NEDO-31960-A
Class I
November 1995

Licensing Topical Report

**BWR Owners' Group
Long-Term Stability Solutions
Licensing Methodology**

LONG TERM STABILITY SOLUTIONS
LICENSING METHODOLOGY

Figure A.1. Comparison between corewide decay ratios calculated by LAPUR and FABLE.

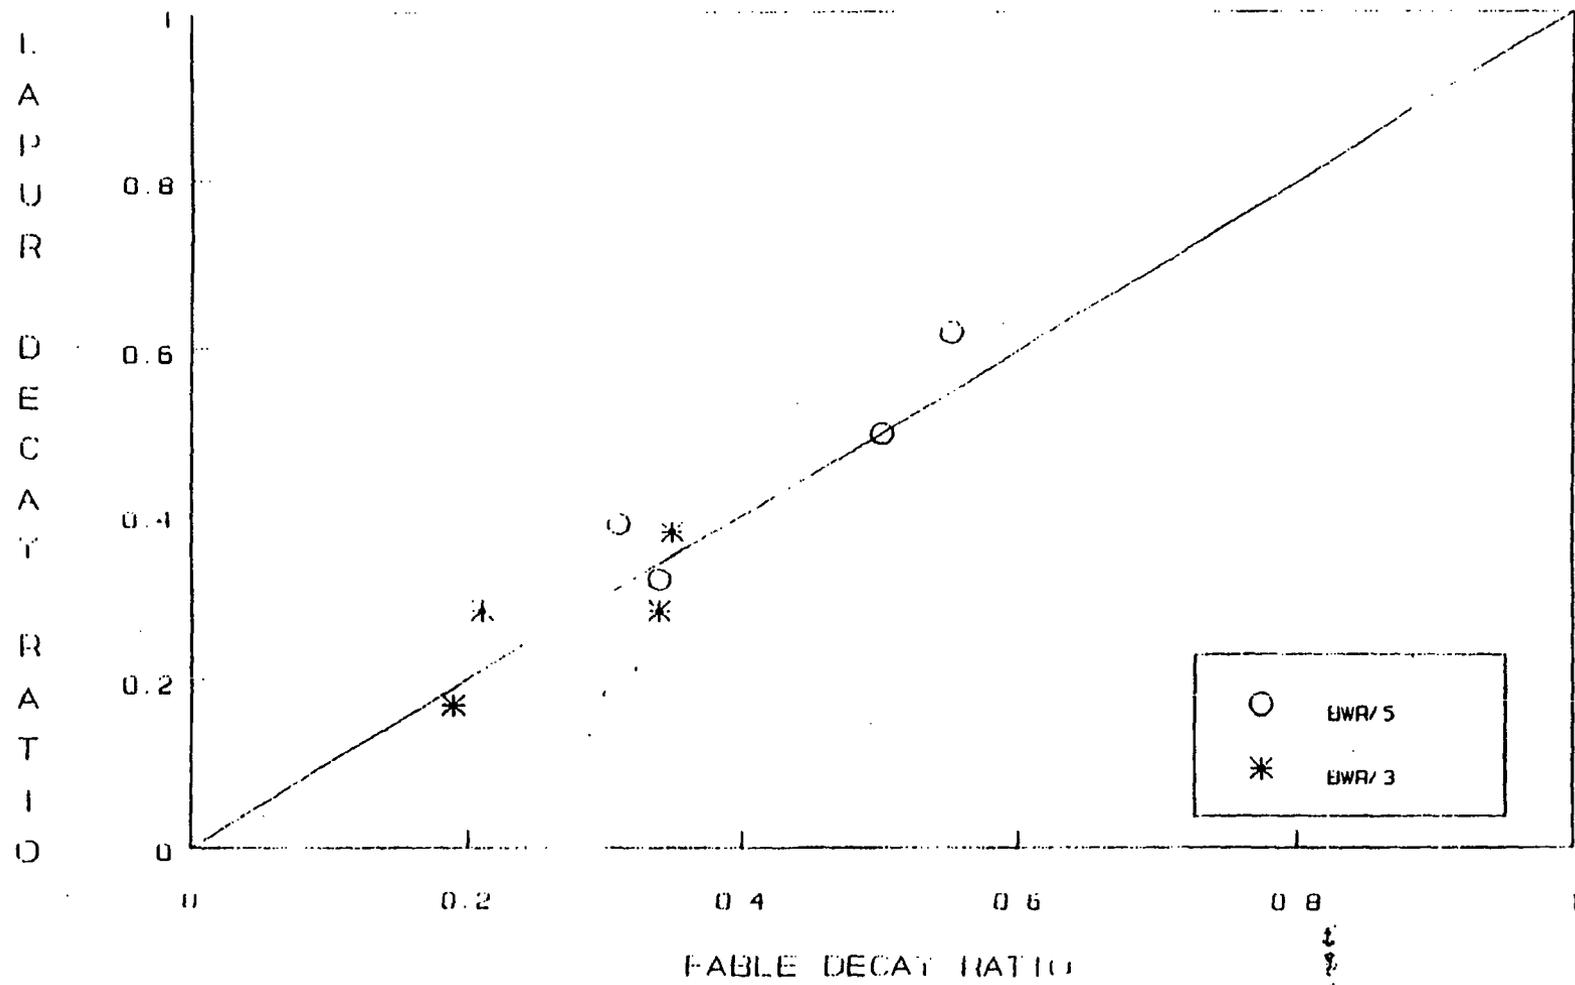
A series of audit calculations were performed with the LAPUR code to verify the results presented by the BWROG that were based on FABLE/BYPSS calculations. All relevant input data used in the FABLE/BYPSS was made available for this review, and we set up LAPUR input decks that were representative of the conditions modeled by FABLE. The main result of these calculations is presented in Table A.1 and Figs A.1 and A.2. We observe that the maximum difference between LAPUR- and FABLE-calculated decay ratios is 0.09. This can be considered as excellent agreement and representative of the differences in modeling of both codes.

Figure A.5. Comparison between equilibrium-cycle exclusion region and the exclusion region for the specific operating conditions of a BWR/5 instability event.

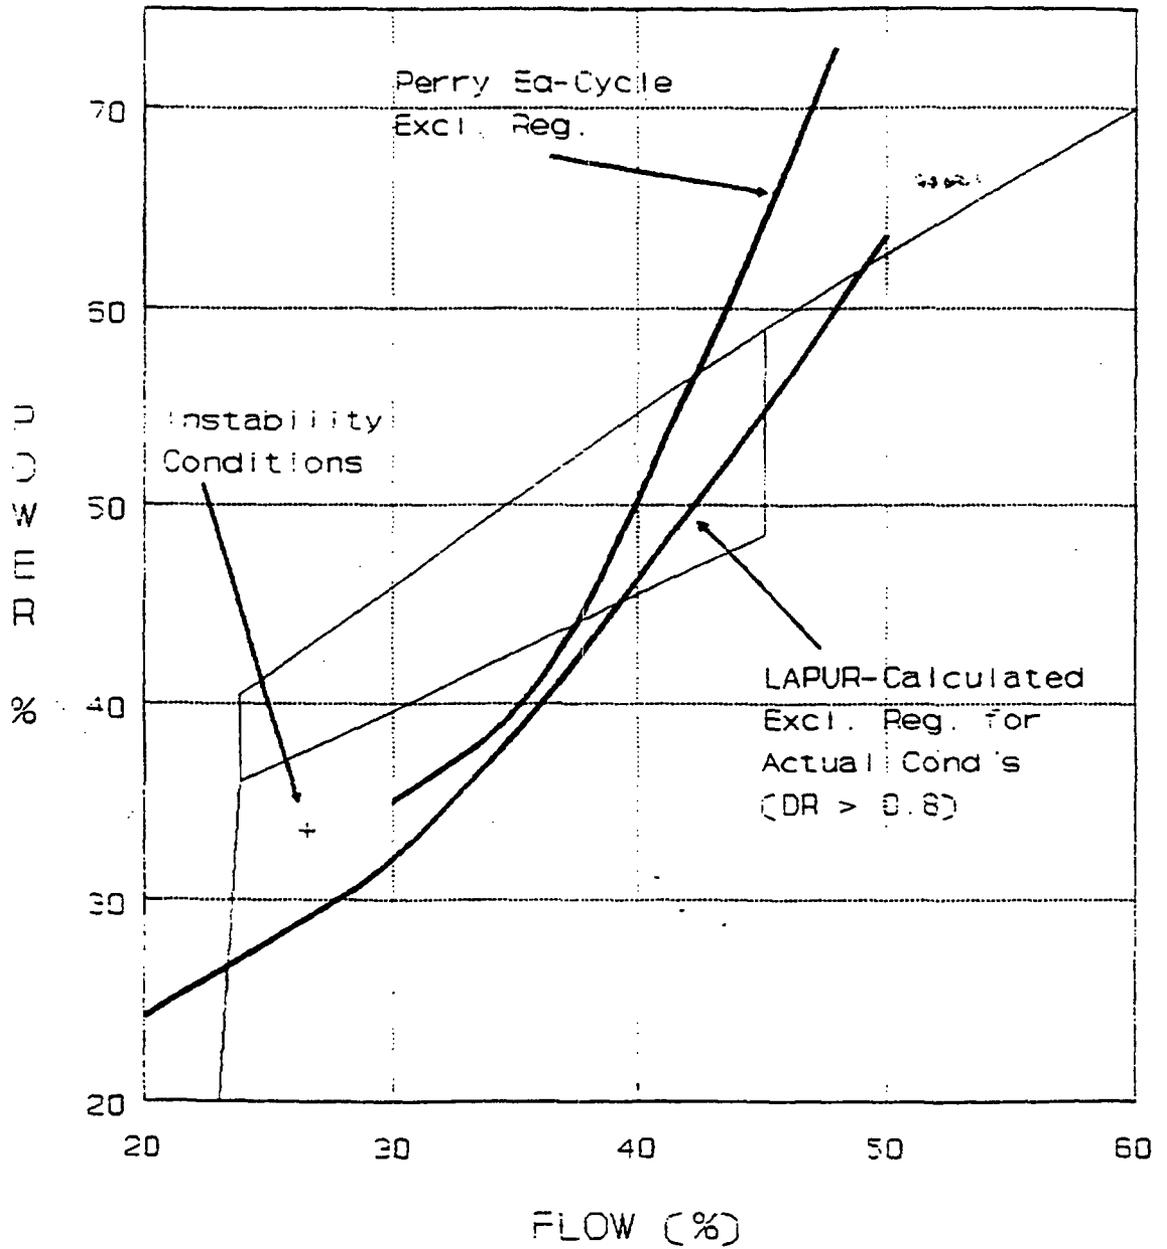
Figure A.5 shows a comparison of the equilibrium-cycle exclusion region for the Perry reactor (a BWR/6) and the exclusion region that results if the actual axial and power shapes from the recent BWR/5 event are used. As it can be observed, the standard BWR/6 exclusion region from NEDO-31960 is not as conservative as the actual region. Therefore, we have recommended that the BWROG must establish a criteria to limit the actual radial and axial peaking factors during startup operations to those values considered for the analyses of the exclusion region. This criteria must be based on parameters or information readily available to the operator in the control room.
